Re: Appeal of Historic Preservation Commission Decision – 1917 Center Street Project

CERTIFICATE OF APPROPRIATENESS

REQUEST FROM: : CASE NUMBER: CAHP-2025-000046

1917 CENTER STREET :

1917 CENTER ST - FLOORPLANS

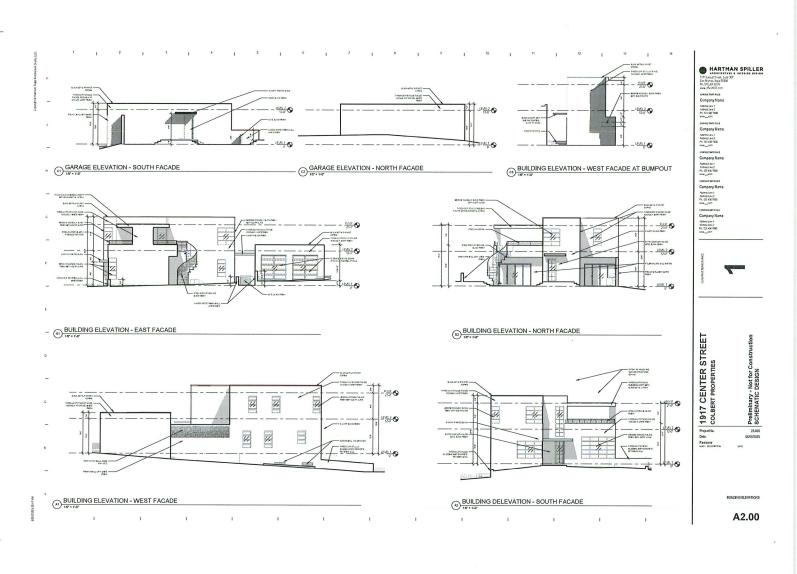
- A finished basement with an egress well.
- First-floor plan shows exterior areas and detached garage.
- Second-floor plan includes the covered balcony/patio area.
